SARA reference: 2604-51886 SRA
 Council reference: CA 2025_5880/1
 Applicant reference: 2025-09-82 - Seymour Group

SARA referral agency response – 71-85 Port Douglas Road, Port Douglas

Description:	Development permit	Reconfiguring a lot (1 lot into 40 lots and common property)
	Preliminary approval	Material change of use for use rights consistent with the low-medium density residential zone and to vary the effect of the planning scheme by amending the table of assessment for short term

DRAWING TITLE		
PRELIMINARY STORMWATER DRAINAGE CATCHMENT PLAN		
PROJECT NUMBER	DRAWING NUMBER	REVISION
BE25041-001	DA400	1

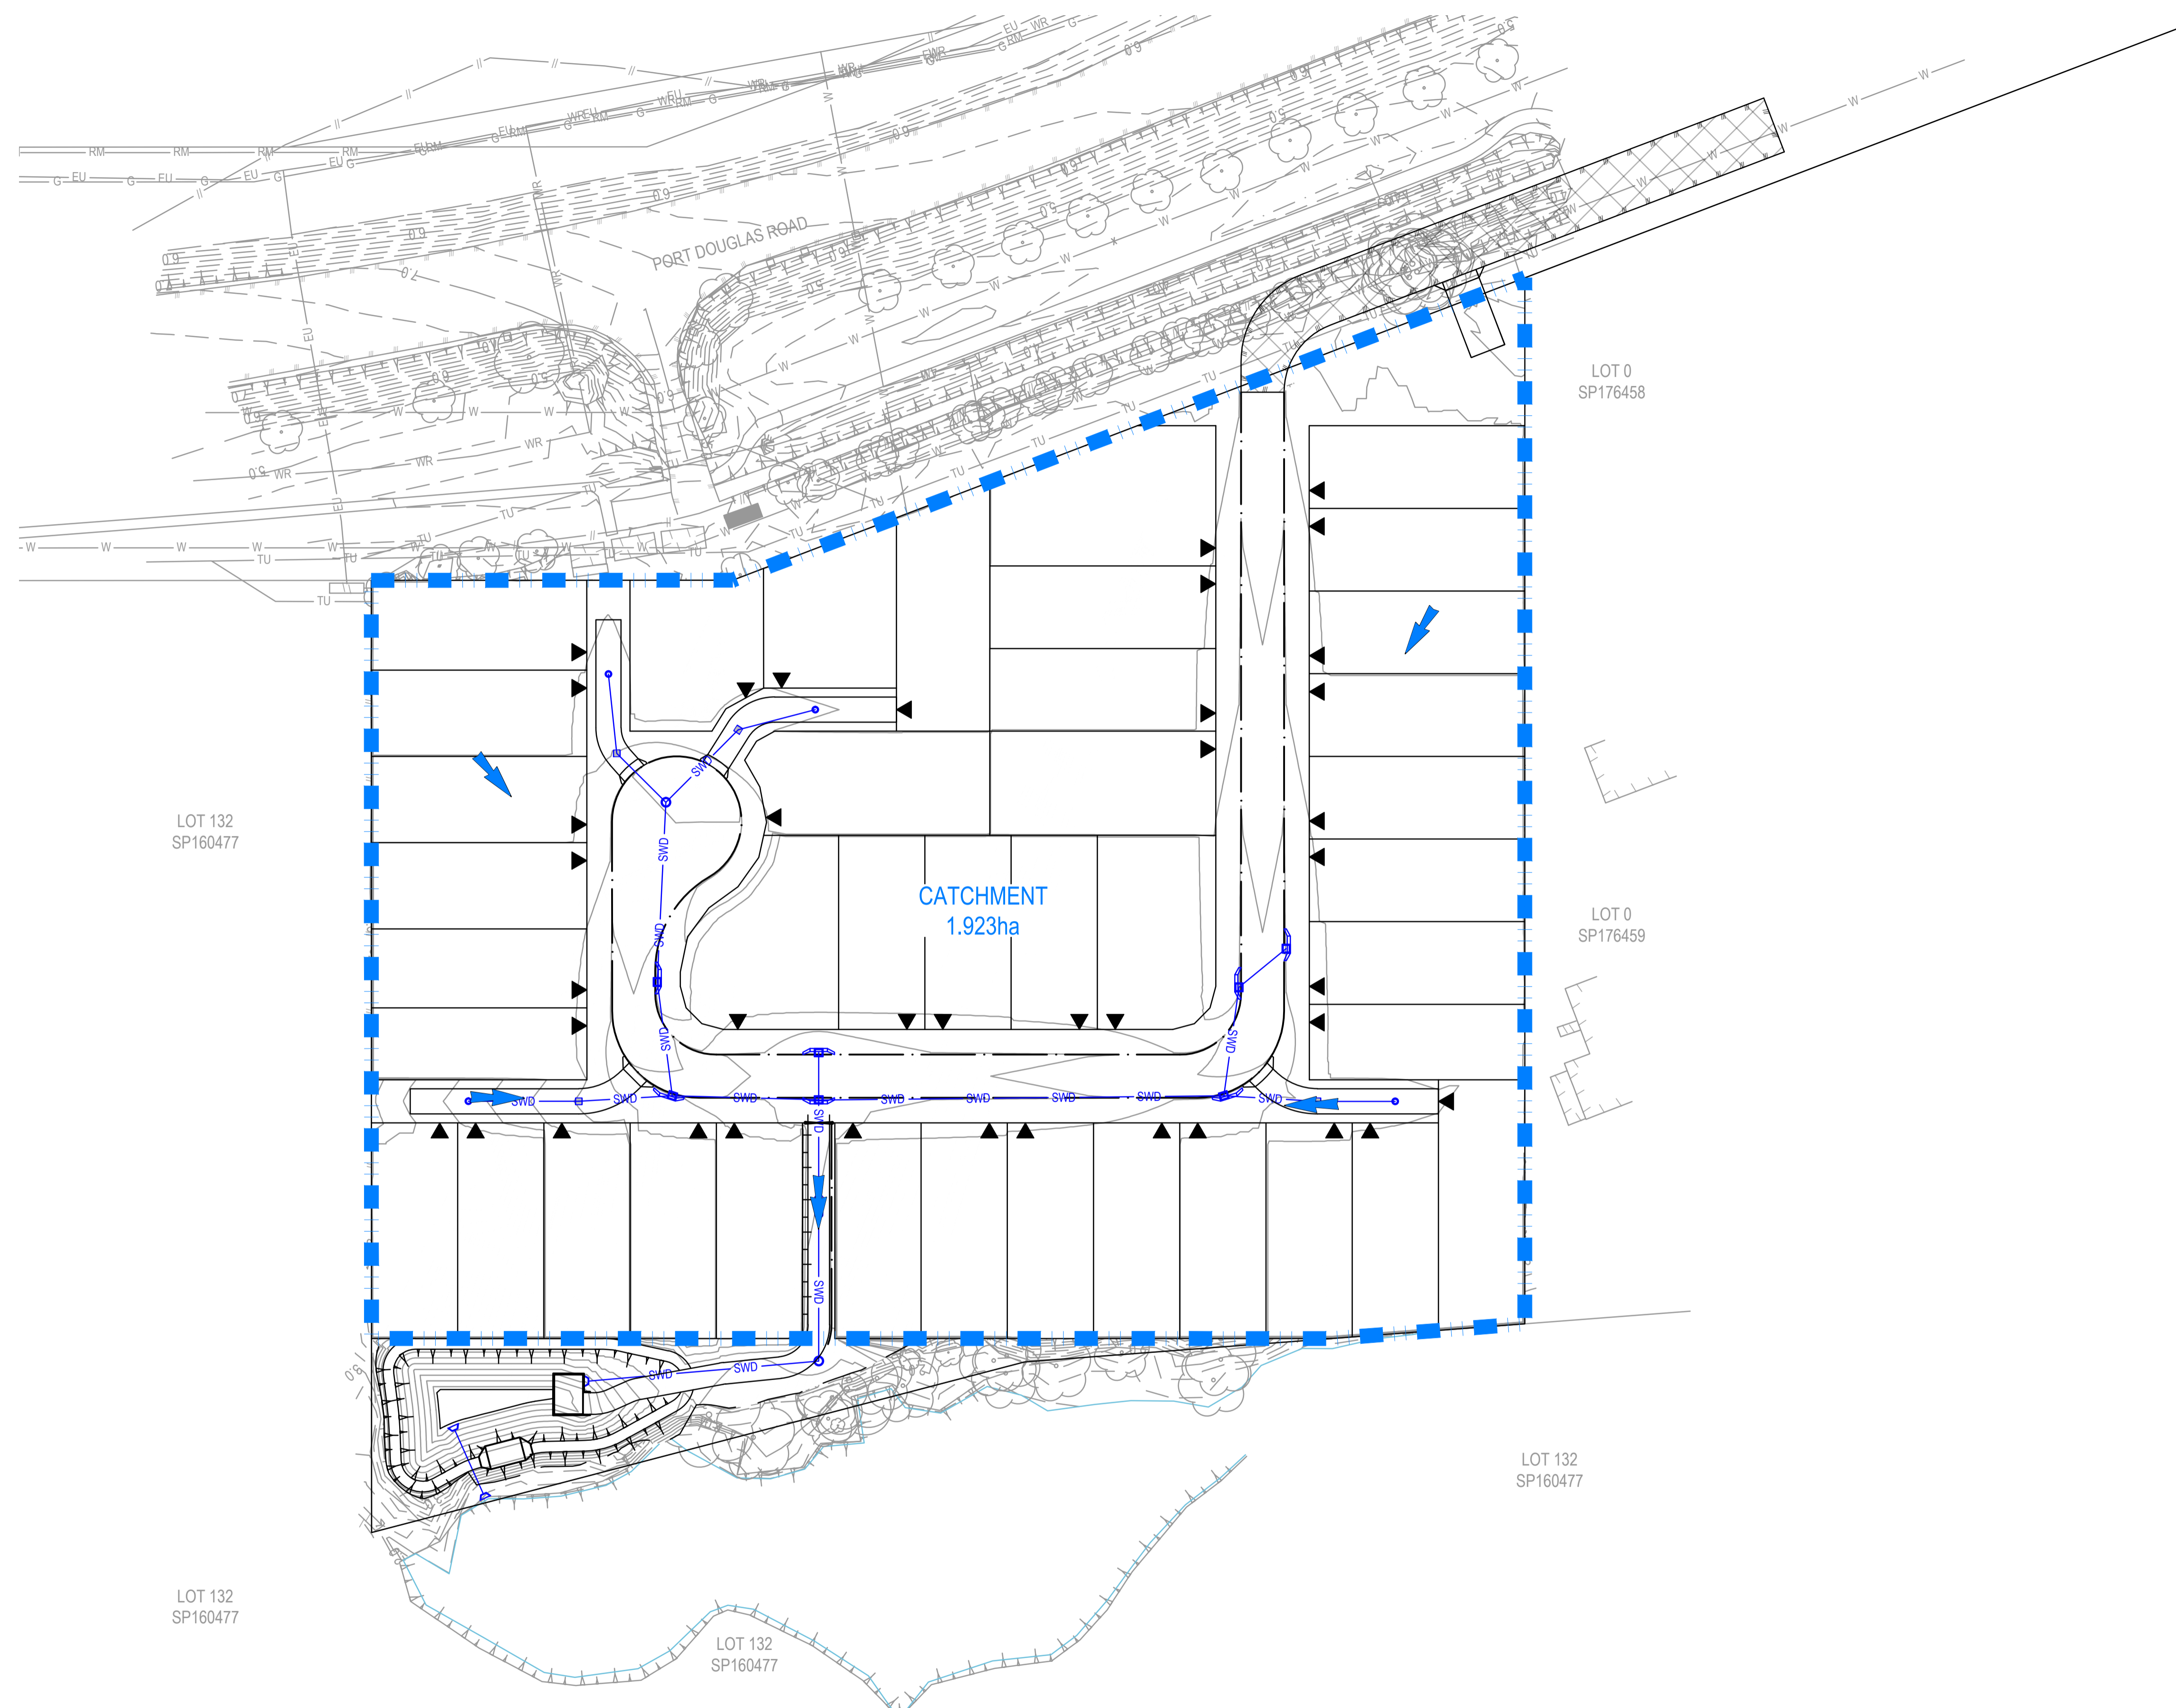
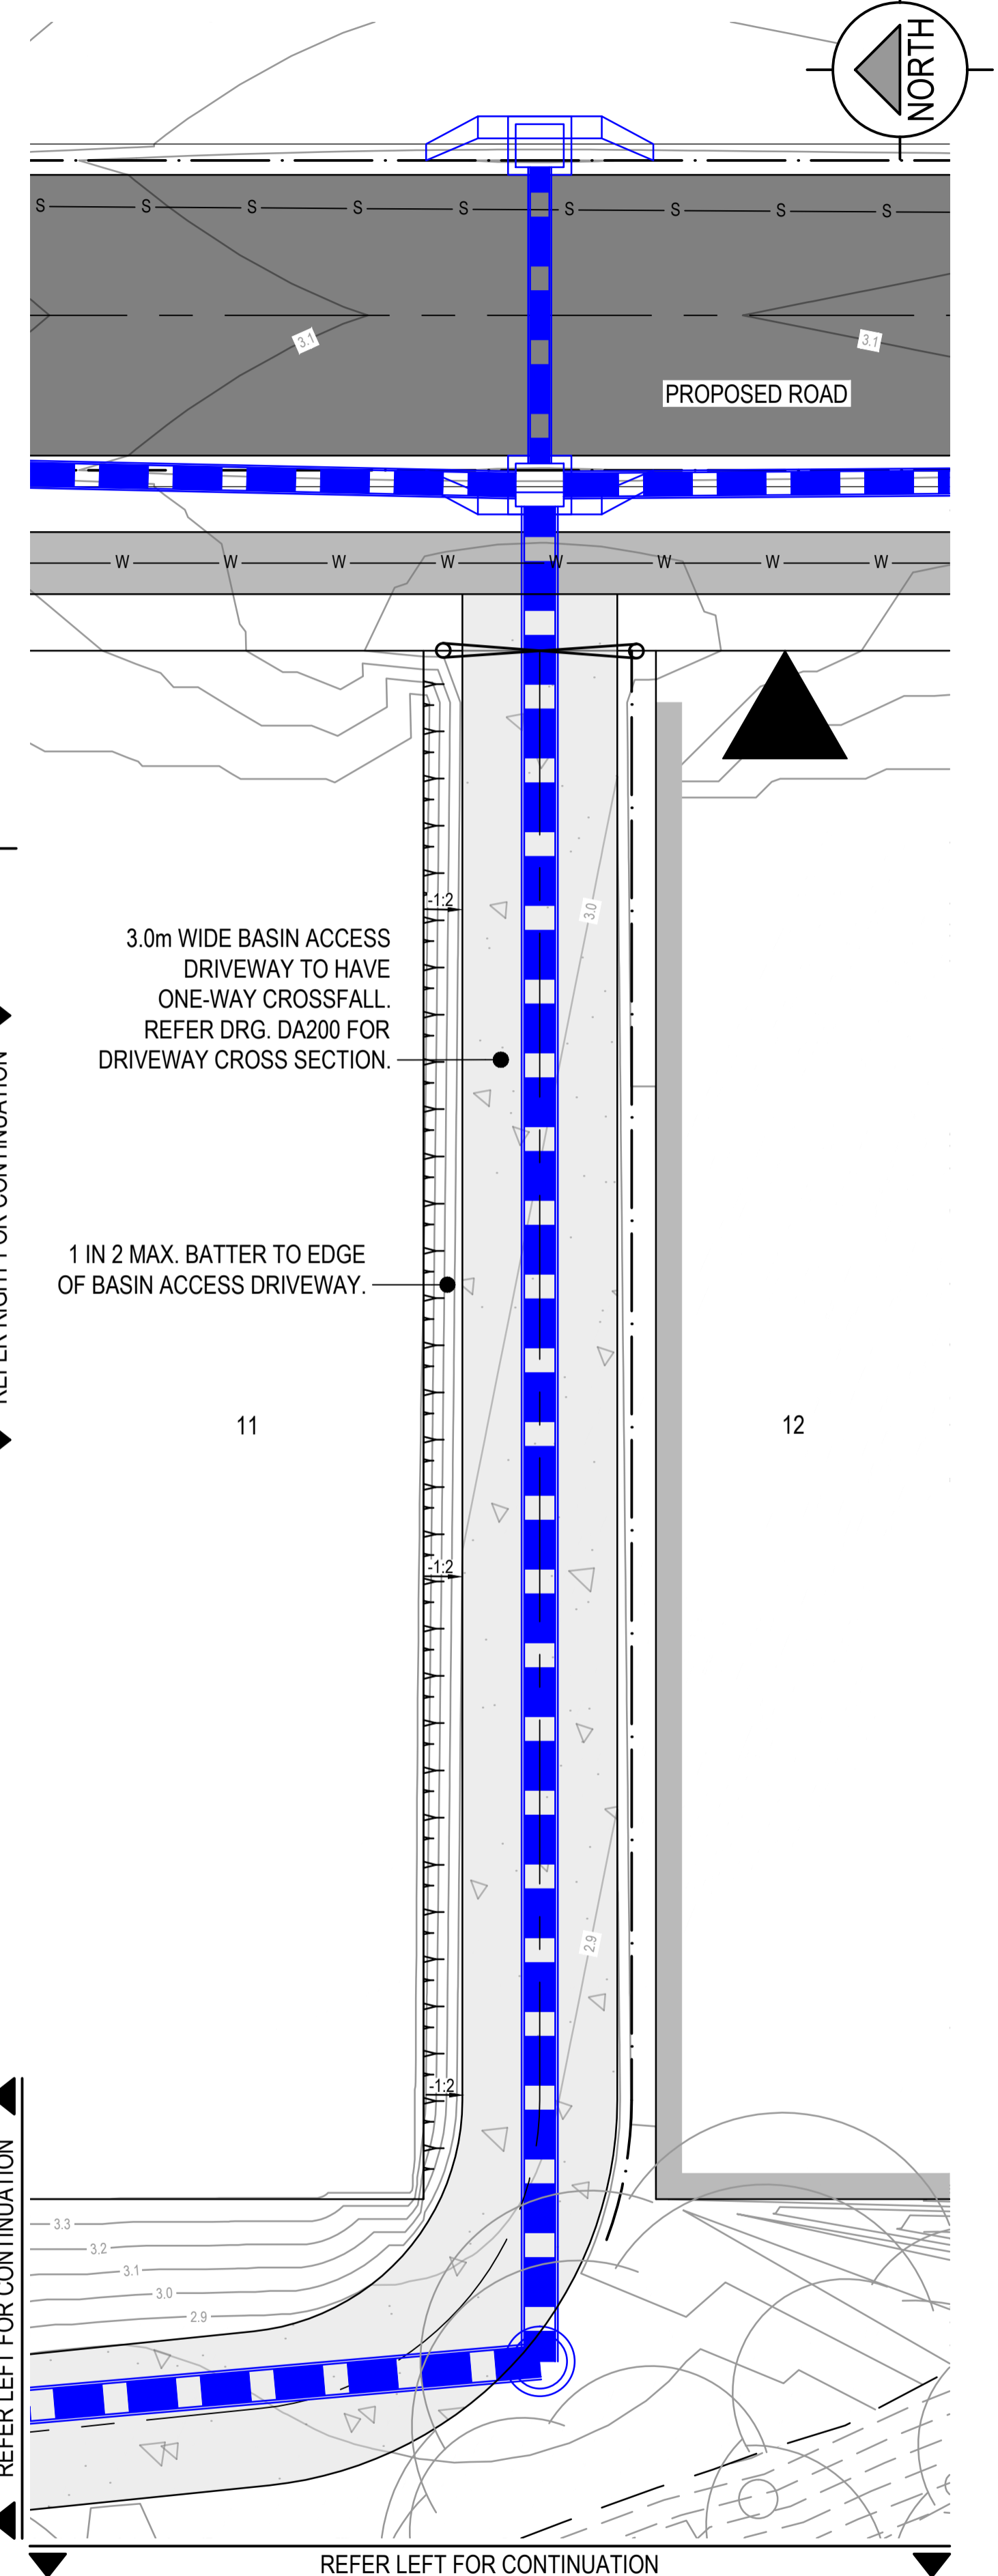
1.	<p>Stormwater infrastructure works must be undertaken generally in accordance with the following plans:</p> <p>(a) Preliminary Stormwater Drainage Catchment Plan prepared by Bourn Engineers, dated 18.12.2025, Drawing DA400, Revision 1.</p> <p>(b) Preliminary Detention Basin Layout Plan prepared by Bourn Engineers, dated 18.12.2025, Drawing DA401, Revision 1.</p>	<p>Prior to submitting the Plan of Survey to the local government for approval.</p>
